Access Compliance Report

Public Rights-of-Way

(Curb Ramps)

Intersection ID: N/A	Main Street: E_INDEPENDENCE_BV	Cross Street: N/A	Location: W
ADA ID: E7812BFC3105	Ramp Type: IslandPara	Initial Pass/Fail: Fail	Overall Compliance: No
Codes/Mitigation Info/Possible Solution		Field Measurements/Component Compliance	
Severity Score: 22.5

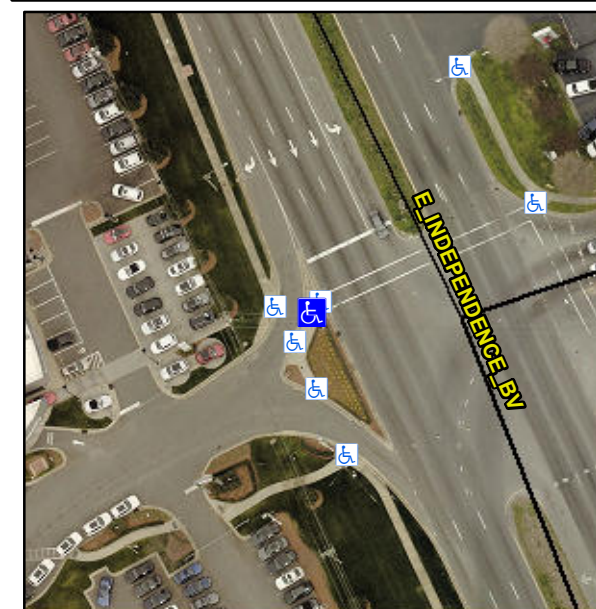
R304.5.1, R304.3.2, R304.5.3

Compliance	Description	Data	Compliance	Description	Data
N/A	Ramp Length LT (in)	79.0	N/A	Ramp Length RT (in)	72.0
No	Ramp Width LT (in)	38.5	Yes	Ramp Width RT (in)	80.0
No	Ramp Slope LT (%)	9.0	Yes	Ramp Slope RT (%)	6.1
No	Ramp XSlope LT (%)	4.0	No	Ramp XSlope RT (%)	2.2
N/A	Landing Length (in)	N/A	N/A	DWS Provided?	N/A
N/A	Landing Width (in)	N/A	N/A	DWS Contrast?	N/A
N/A	Landing Slope (%)	N/A	N/A	DWS Length (in)	N/A
N/A	Landing X Slope (%)	N/A	N/A	DWS Full Width?	N/A
N/A	Landing Curb? (Y/N)	N/A	N/A	DWS Offset (in)	N/A
N/A	Shared Landing?	N/A			
N/A	Gutter Ponding?	N/A	N/A	Gutter Slope (%)	N/A
N/A	Gutter Lip Ht (in)	N/A	N/A	Gutter X Slope (%)	N/A
N/A	Painted X Walk1?	No	N/A	Painted X Walk2?	N/A
	X Walk 1 Direction	To W		X Walk 2 Direction	N/A
N/A	X Walk 1 Width (in)	N/A	N/A	X Walk 2 Width (in)	N/A
	X Walk 1 Slope (%)	3.4		X Walk 2 Slope (%)	N/A
	X Walk 1 X Slope (%)	1.8		X Walk 2 X Slope (%)	N/A
N/A	Ramp inside XWalk1?	N/A	N/A	Ramp inside XWalk2?	N/A

Road Slope (%)	N/A	N/A	Clear Space?	N/A
	Road X Slope (%)	N/A	N/A	Clear Space to XWalk (in)	N/A
N/A	Any Obstructions?	N/A	N/A	Storm Grate/Utility Hazard?	N/A
	Obstruction Type			Storm Grate/Utility Type	
		N/A			N/A
			Yes	Surface Condition? (G/P)	Good
			N/A	Curb Slope (%)	15.8

Remove & Replace Entire Ramp.
